DEVIATION REQUEST (Attach diagrams, figures, and other documentation to clarify request)

A deviation from the standards of or in Section **2.3 Roadway Design** of the Engineering Criteria Manual (ECM) is requested.

Section 2.3 Roadway Design, Detail SD_2-11

SD_2-11 Typical Rural Local Cross Section

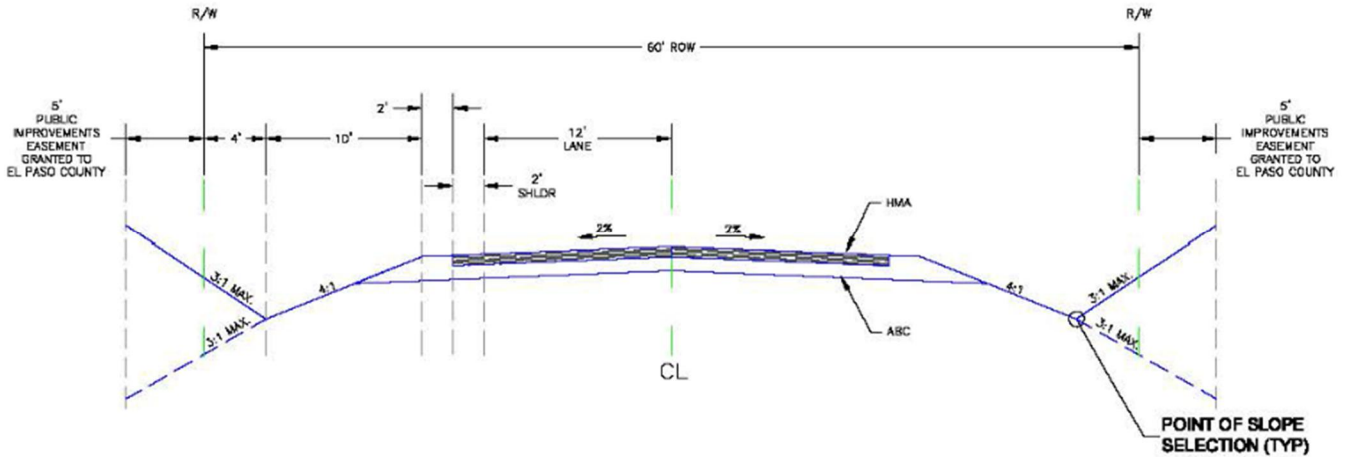
A request to modify the typical rural local cross section allows for an 8-foot regional trail to be constructed along the south side of Apex Ranch Road. The EPC Parks department has requested a proposed 25' easement outside of the right of way will reserve adequate space for the trail to be built at a future date along the Apex Ranch Road alignment. This will connect Homestead Park (El Paso County Park) to Tract E and D within the Apex Ranch Subdivision, which are dedicated for public trail use.

A modified typical section illustration is provided below:

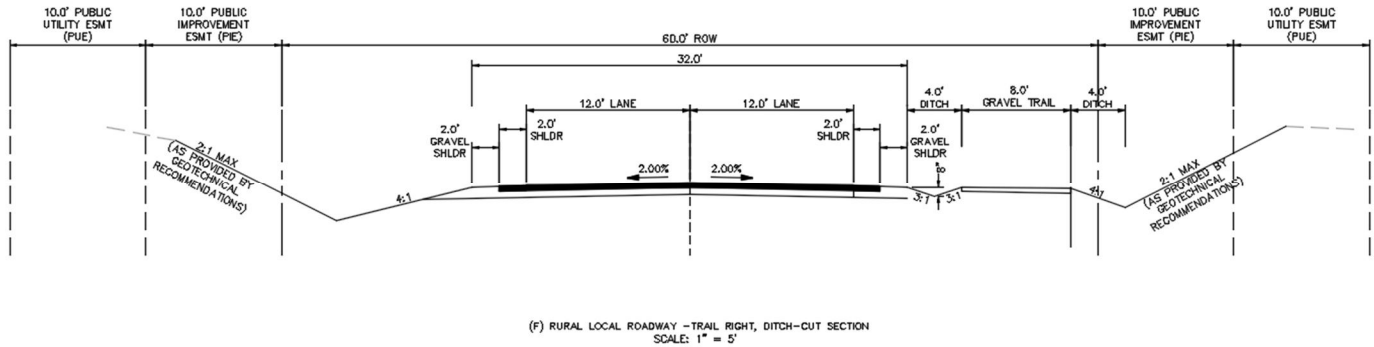
There is one portion of the proposed Apex Ranch Road alignment that has significant grade challenges to traverse to the top of an existing plateau. The existing topography has over 30% grades and the proposed roadway will use a 10% grade through this section of the plateau. Due to the large amount of earthwork to make this roadway cut, a modified street section is being proposed to allow for the regional trail to be a closer offset from the roadway section, within the right of way.

The proposed modified cross section intends to closely follow the Rural Local Cross Sections SD_2-11 with the following modifications:

1. 2:1 backslopes (as provided by geotechnical engineering recommendations), to accommodate large cut sections
2. 8-foot trail on the right side of the alignment
3. A 4-foot, 8 inch deep, roadside ditch between the trail and gravel shoulder for drainage runoff from the right lane of the proposed roadway
4. A 1-foot-deep roadside ditch between the trail and the 2:1 slope
